CITY OF ALBUQUERQUE

Re: CNM Hazeldine Sidewalk Culvert Plan, 725 University Blvd (culvert on Hazeldine St.)

Engineer's Stamp dated 10-7-10 and 10-26-10 (K15/D076)

Based upon the information provided in your submittal received 10-26-10, the above referenced plan is approved for SO 19 Permit.

DRAINAGE
SIDEWALK CULVERT
WITH STEEL PLATE TOP
DWG. 2236 (MODIFIED)

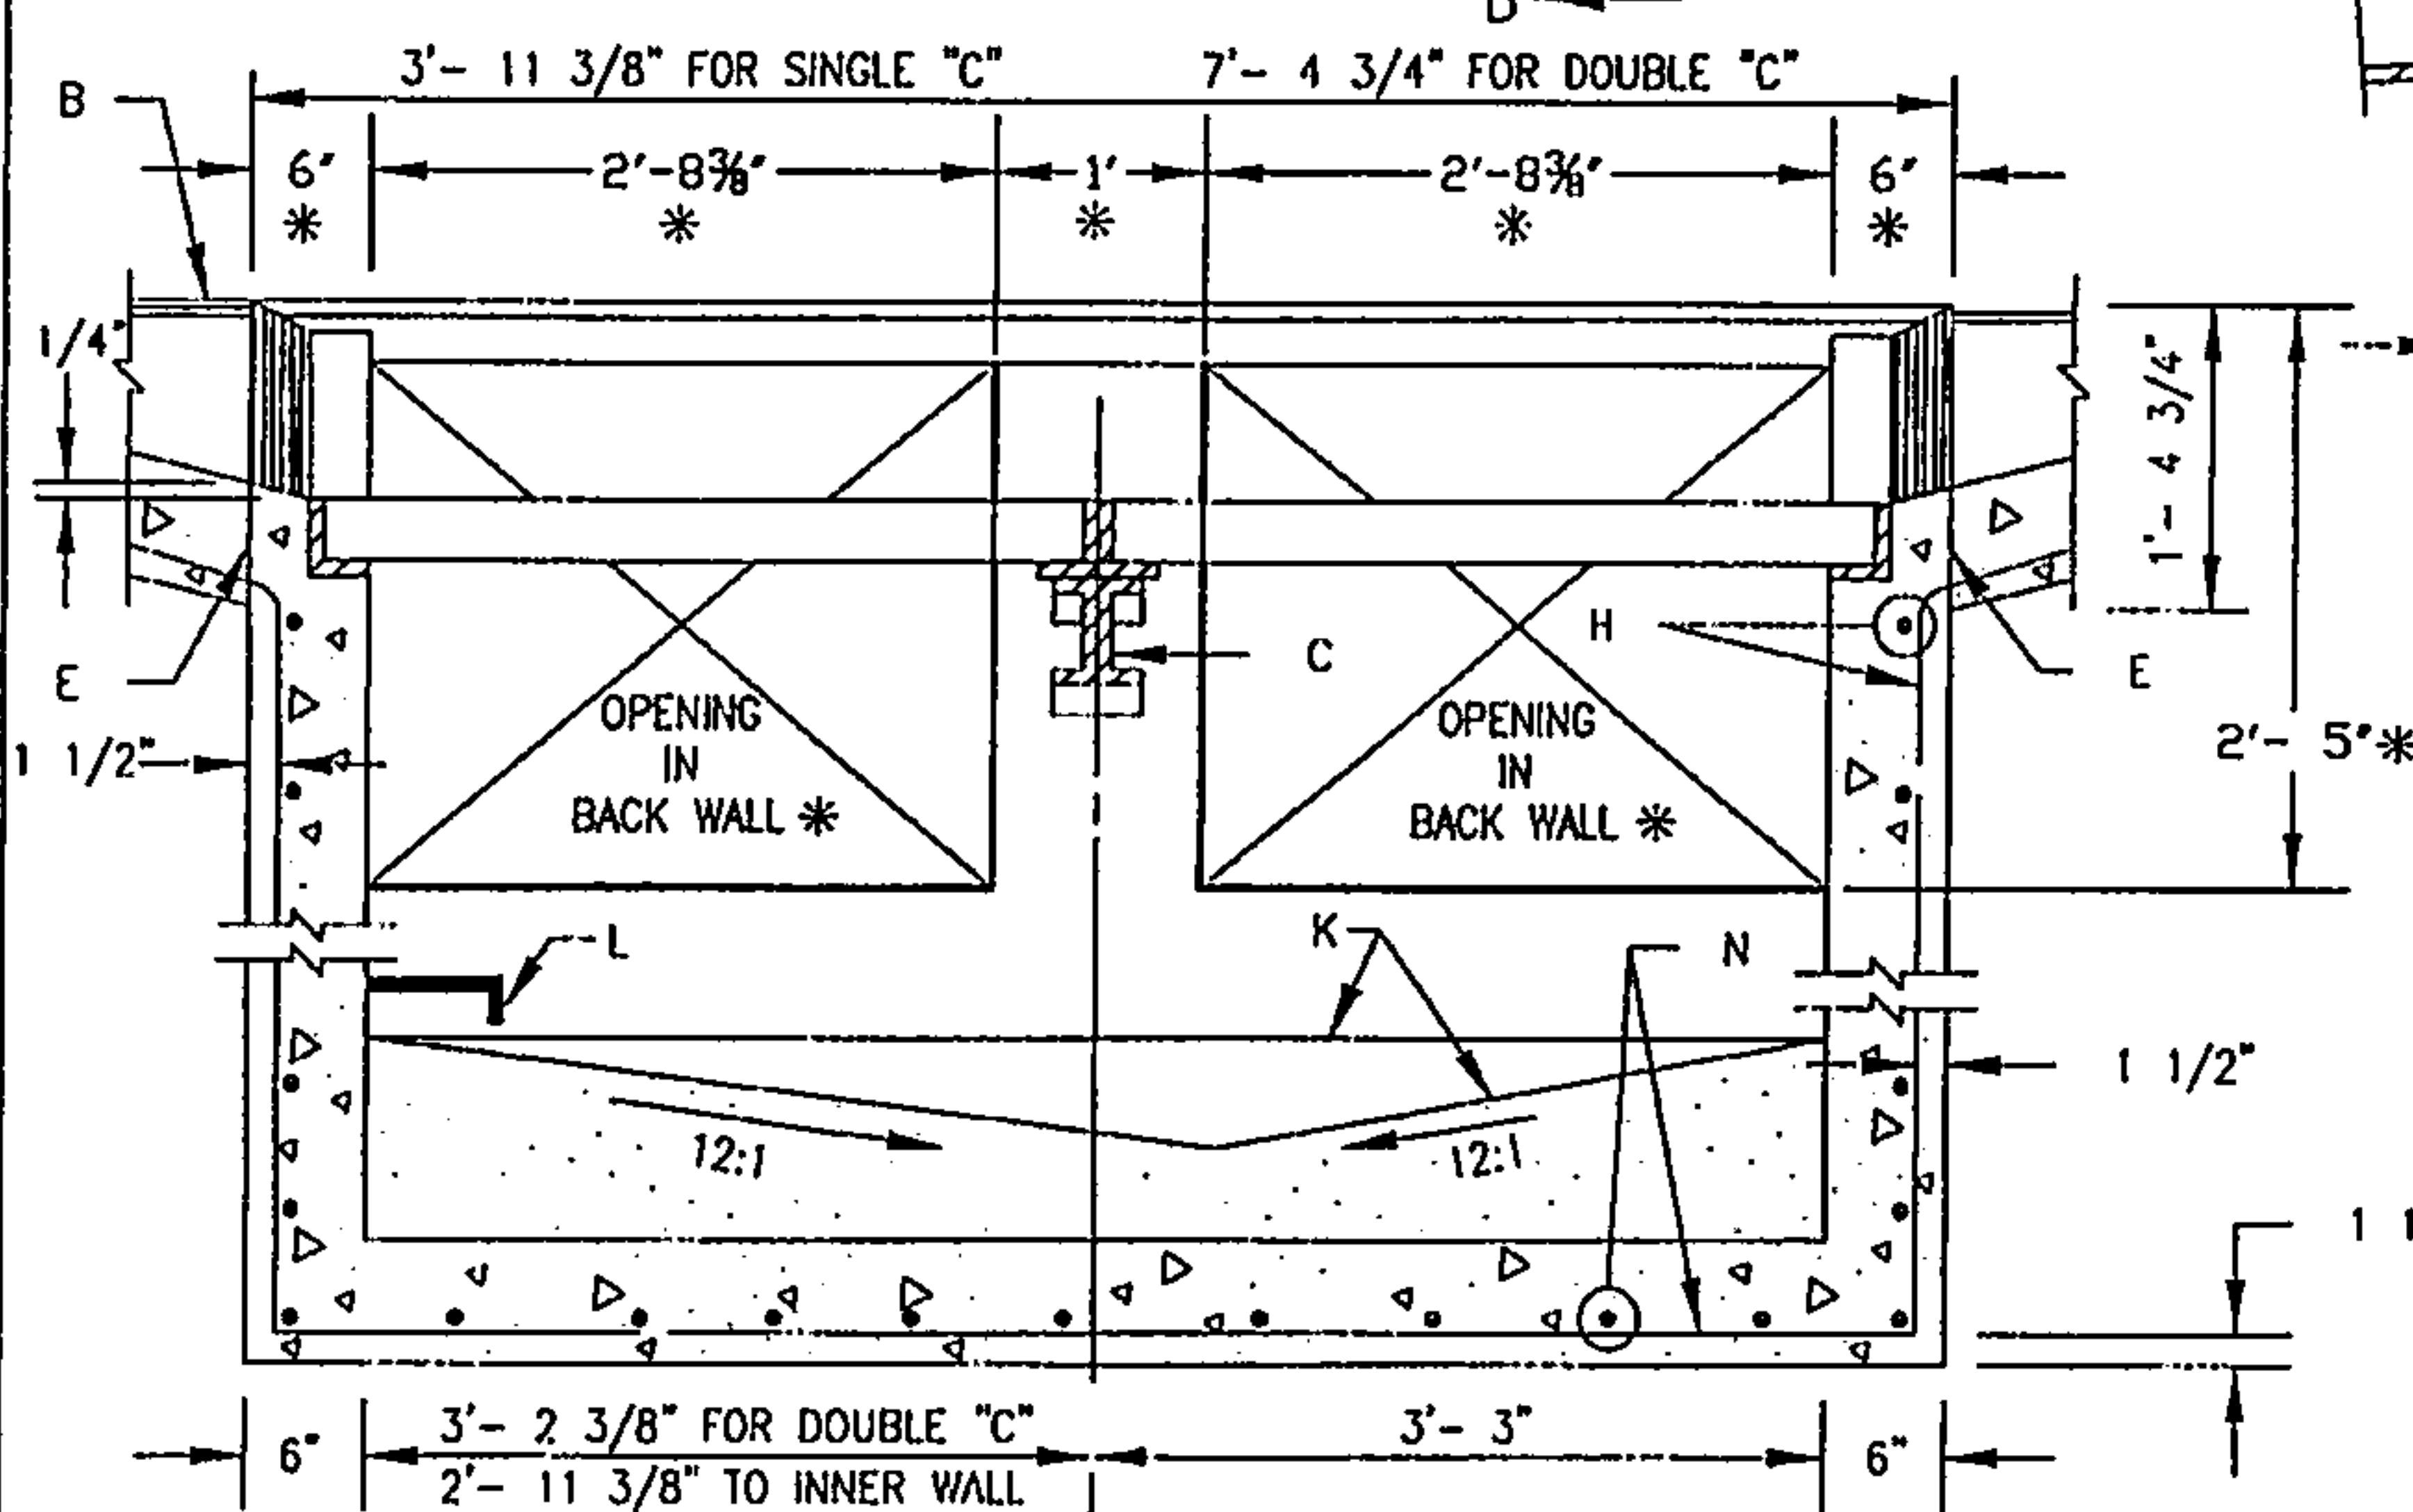
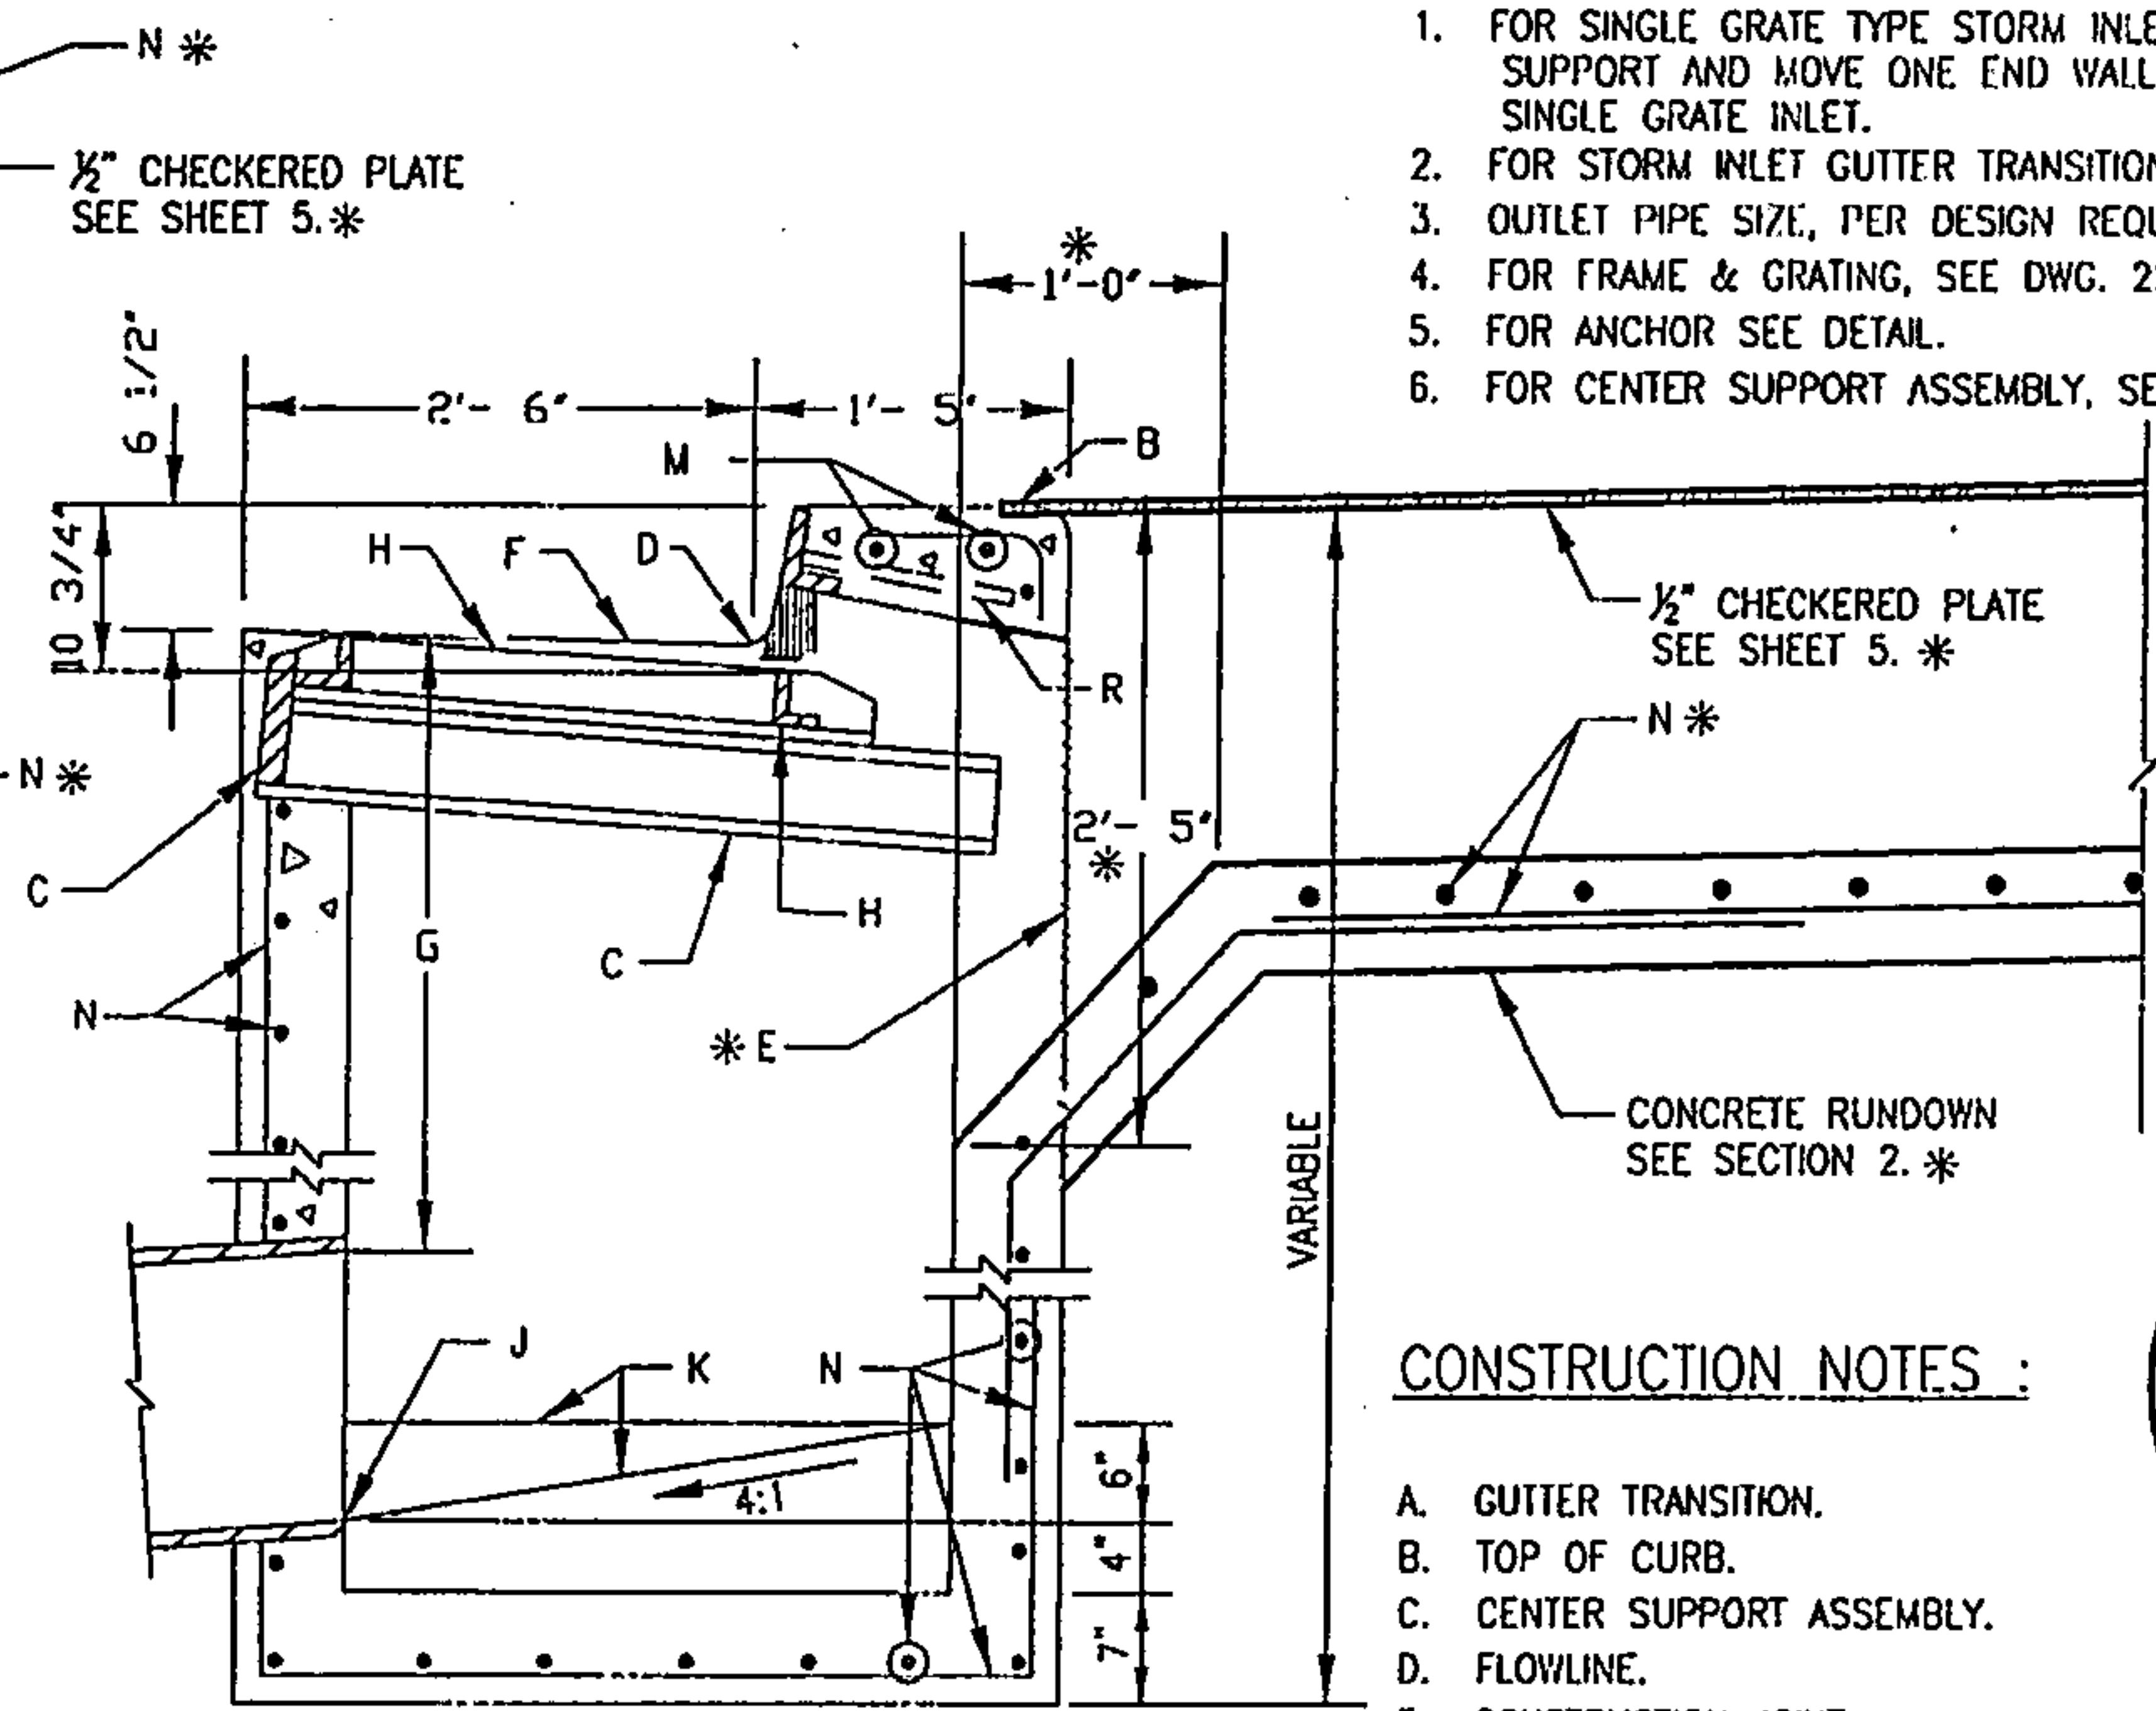
1. Show the property line. Are you planning on staying in the ROW?
2. Should you have a slope specified on the asphalt overlay sections? How do you know 4" will work?
3. Specify the type of asphalt and you'll probably need 2 lifts where it is 4" thick.
4. Provide the depth of the sidewalk culvert in Section A-A on DWG 2236 (Modified).
5. There should be a PE stamp on this.
